ADDENDUM NO. 1

**TAYLOR MILL TREATMENT PLANT BELT FILTER PRESS REPLACEMENT
NORTHERN KENTUCKY WATER DISTRICT**

GRW PROJECT NO. 4384

January 19, 2017

PARTIAL SECOND FLOOR ELECTRICAL PLAN - NEW WORK

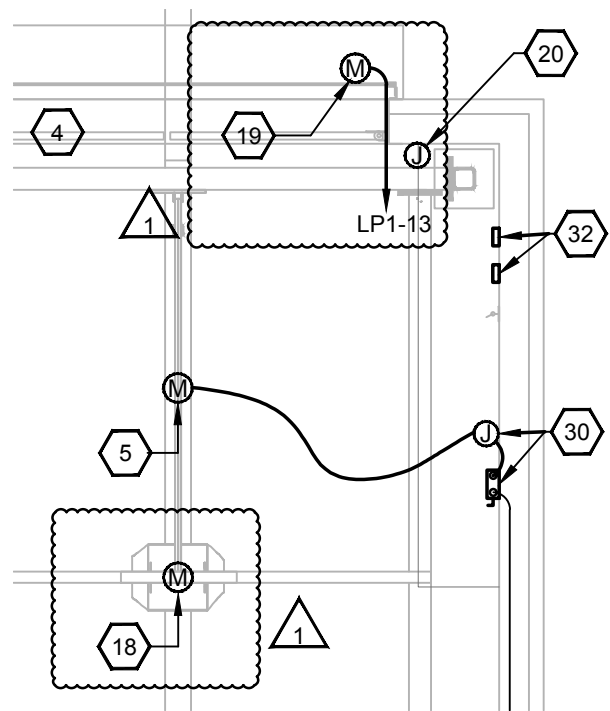
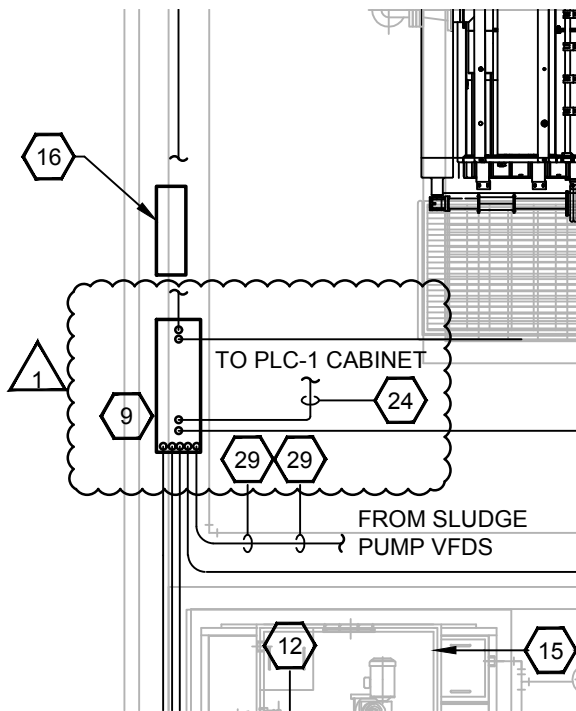
The conduit lines drawn from the Belt Filter Press and the Eye Wash Station have been revised to more clearly show their connection to PLC-1. The motor symbols for the retractable beam have been revised to more clearly show their location. See the attached exhibit for the revision.

4. It appears the Belt Filter Press conduit line runs to the Eye Wash Station, according to how the conduit lines are drawn on Sheet E-103.	There are actually two different conduit runs to the PLC-1. One being from the Belt Filter Press and the other from the Eye Wash Station. Sheet E-103 will be revised in the Addendum No. 1 to show this more clearly.

BELT FILTER PRESS - SECOND FLOOR HVAC NEW WORK PLAN - PARTIAL

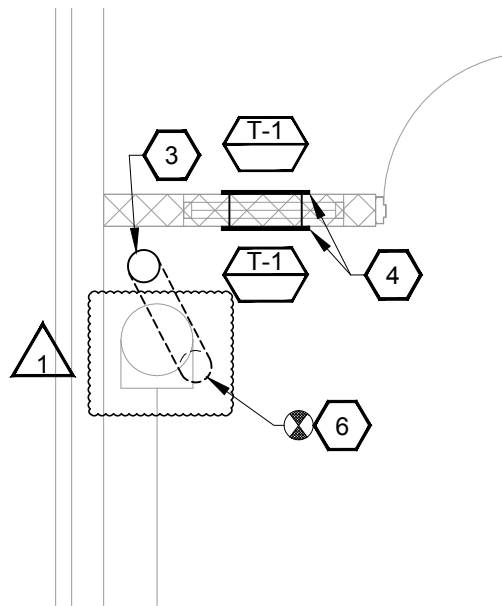
The location of the air compressor was moved 12” down the page to avoid any conflicts with vent piping. See attached exhibit for the revision.

PARTIAL SECOND FLOOR ELECTRICAL PLAN - NEW WORK

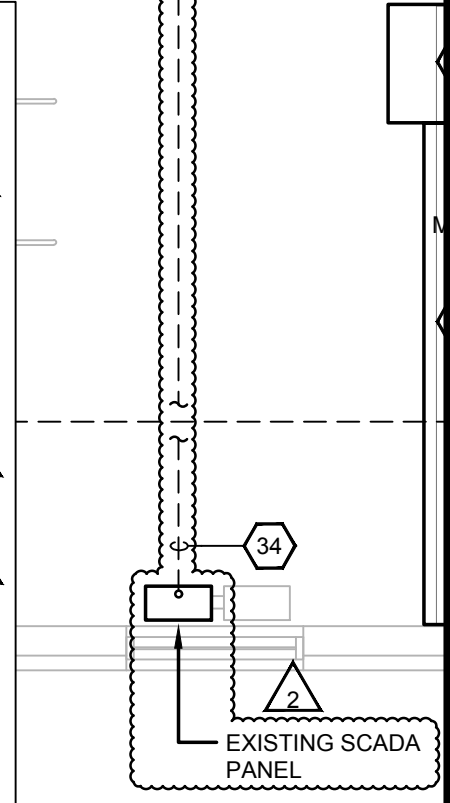
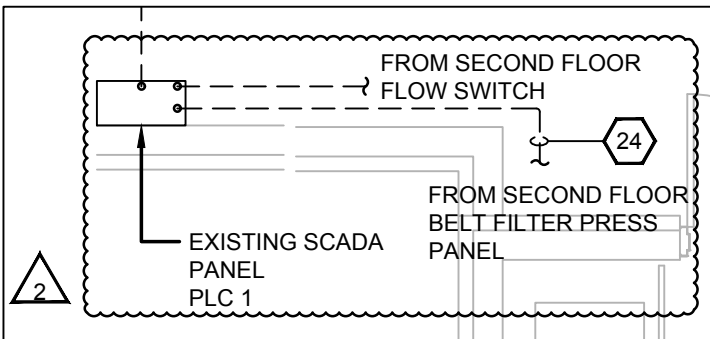
Belt Filter Press Control Panel SCADA connection has been routed to existing SCADA panel located in Belt Filter Press Room. Plans and keynotes have been revised as such. Please see attached exhibit.

9. NEW BELT FILTER PRESS (BFP) CONTROL PANEL. PROVIDE REQUIRED CONNECTIONS TO EXISTING PLANT SCADA AS DETAILED IN KEYNOTES 24 AND 34.

24. (8) #14 IN 3/4" C (INTERLOCKING RELAYS) FROM BFP CONTROL PANEL TO EXISTING SCADA PANEL PLC-1 (LOGIX 5563 BY ALLEN BRADLEY). REFER TO POINT TO POINT DRAWING ON SHEET E-702 FOR LIST OF RELAYS.
